WHITE LAKE TOWNSHIP
ZONING BOARD OF APPEALS

Request Summary: Nonconforming Lot Review

Meeting Date: August 27, 2026

Re: Proposed 2nd Story Addition

Sketch of Survey

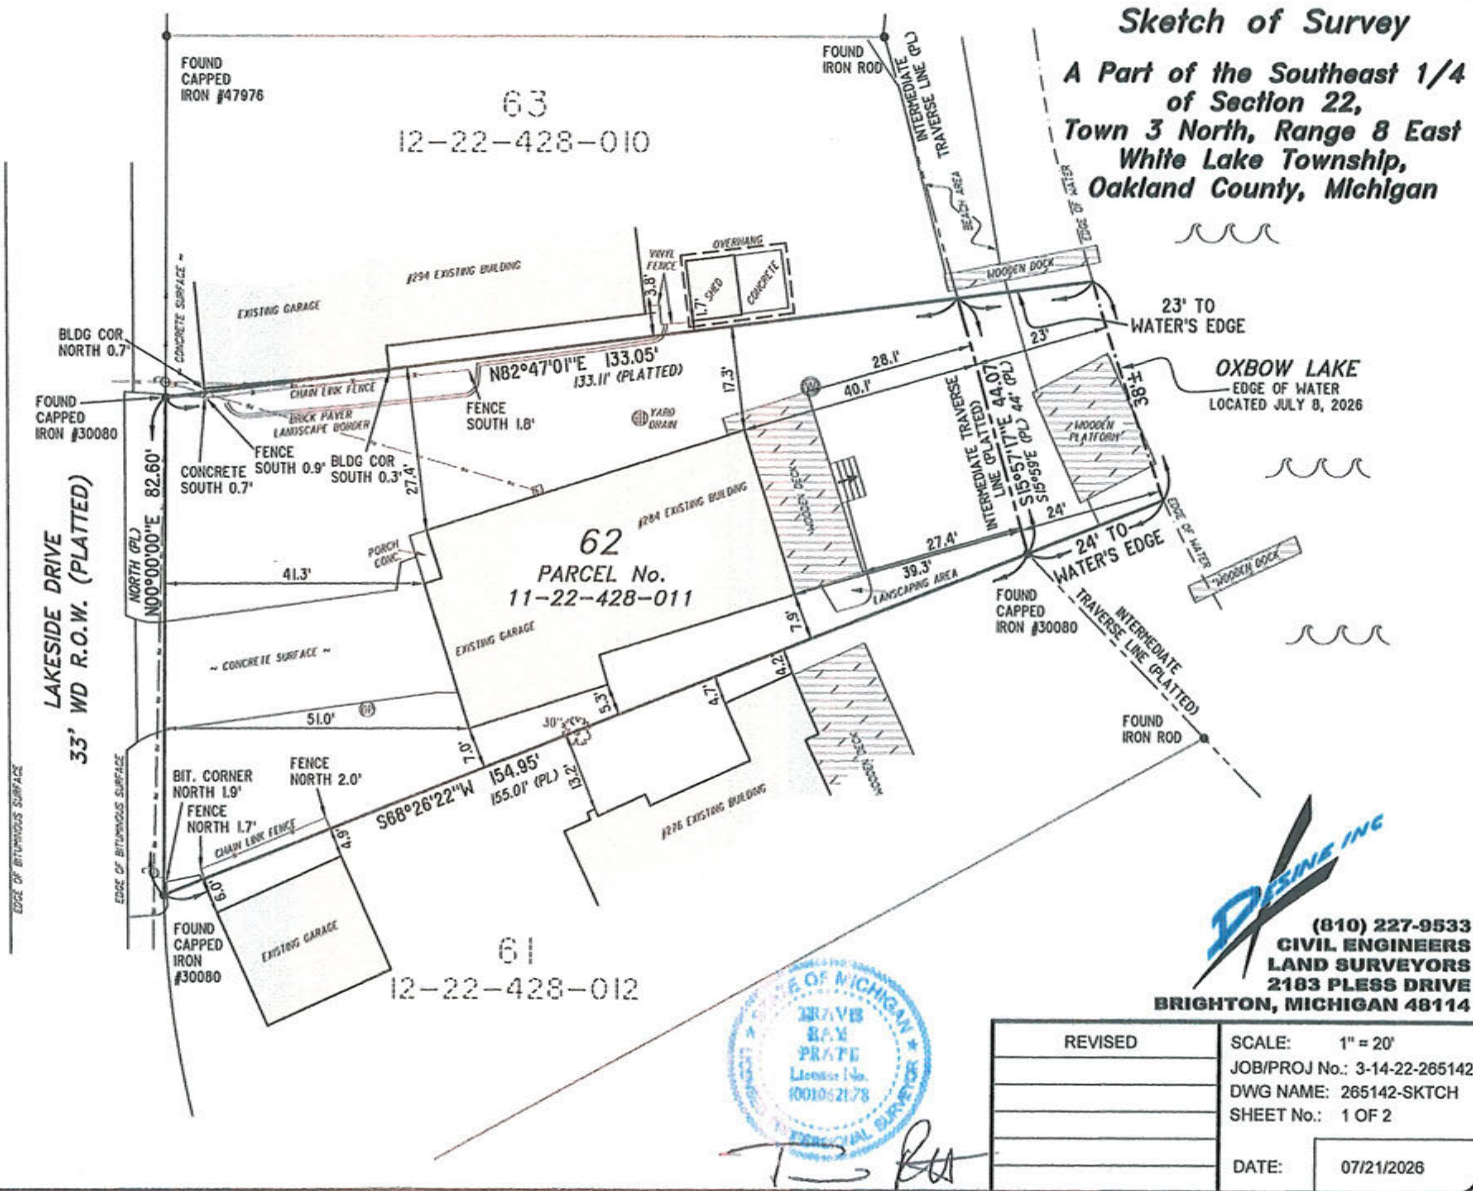
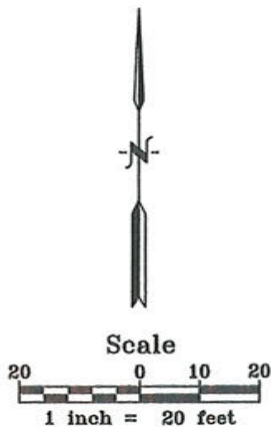
Based on the submitted plans, the existing structure and lot are non-conforming where the lot area is approximately 9,350 sq ft and the existing residential structure has an approximate 5.5 ft side yard setback on the south side. While the proposed 2nd story addition would maintain the existing deficient side yard setback it increases the cubic content of the non-conforming structure over the existing garage by adding living space within the required 10 ft side yard setback.

Furthermore, **Article 5.3** states; in no instance shall any portion of the proposed structure, including overhangs and gutters, project closer than 5 ft to either side yard lot line. **The plot plan should clearly define whether the setback measurement is to the overhang or side wall.** No board, commission or department can grant approval to any structure, or portion of structure within the 5 ft side yard setback.

Approval of the building plans is subject to a variance to the schedule of regulations, Article 7 of the White Lake Township Clear Zoning Ordinance. To be eligible for the July 23rd Zoning Board of Appeals (ZBA) meeting, complete application must be submitted to the White Lake Township Planning Department no later than June 25th at 4:30 PM. ***Be advised, a certified boundary and location survey showing existing structures, proposed structures, and setbacks will be required by the ZBA.*** The Planning Department can be reached at (248)698-3300, ext. 5

SHEET NUMBER
A-2

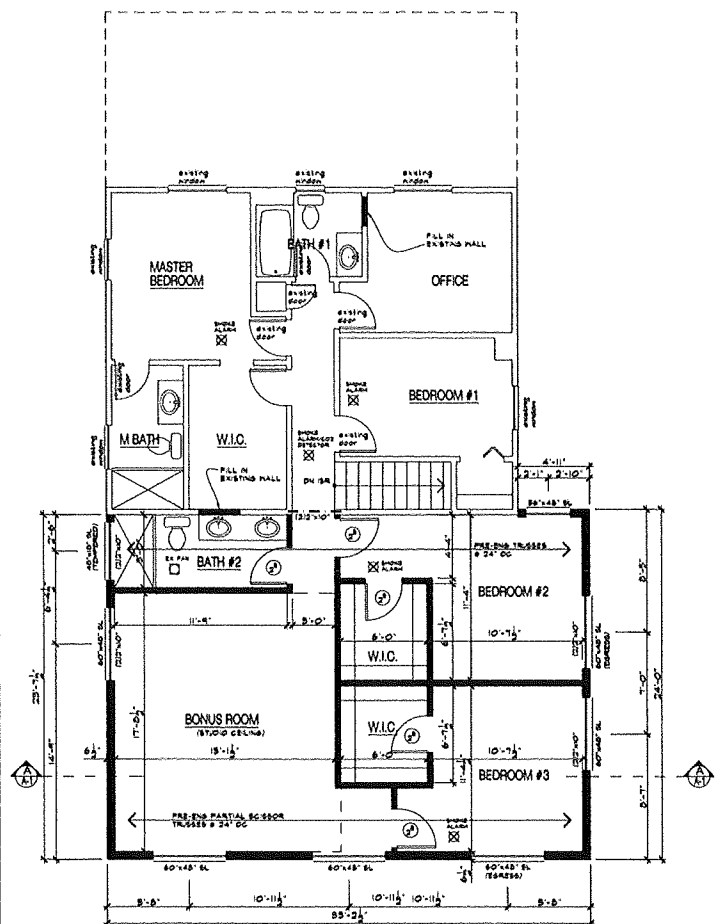
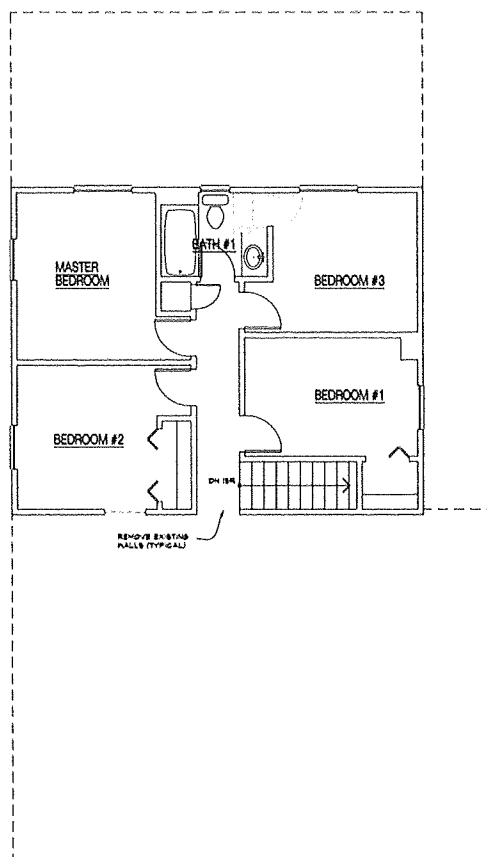
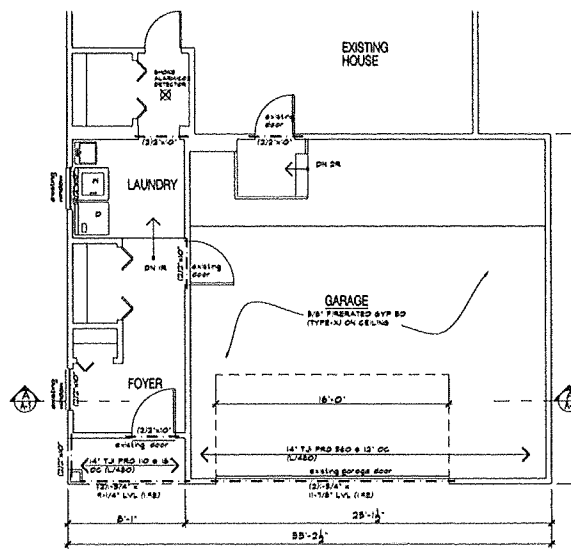
The proposed project would retain the existing single-family residential use and would not expand the ground-level footprint of the dwelling toward the south property line. The addition would instead be constructed vertically above the existing attached garage while maintaining the existing approximately 5.5-foot side-yard setback.

Under Section 5.4, the modified side-yard setback applicable to the property is approximately 8.26 feet. The existing dwelling and attached garage maintain an approximately 5.5-foot setback along the south property line. Rather than extending

the dwelling farther across the lot, the applicant proposes to place the additional living area vertically above the existing garage footprint.

This approach responds to the constrained width and tapered shape of the parcel while avoiding an additional ground-level encroachment. The existing approximately 5.5-foot side yard would also remain above the absolute five-foot minimum established by Section 7.27(B)(vii). No changes are proposed to the existing driveway or access from Lakeside Drive.

The existing dwelling and attached garage maintain an approximately 5.5-foot setback from the south side property line. The proposed second-story addition

would maintain this existing setback and would not extend the structure closer to the property line.

Because the proposed construction would remain more than five feet from the south side lot line, the project complies with the minimum side-yard requirement established by Section 7.27(B)(vii). Final construction plans should continue to demonstrate that all portions of the structure, including applicable overhangs and gutters, remain at least five feet from the property line.
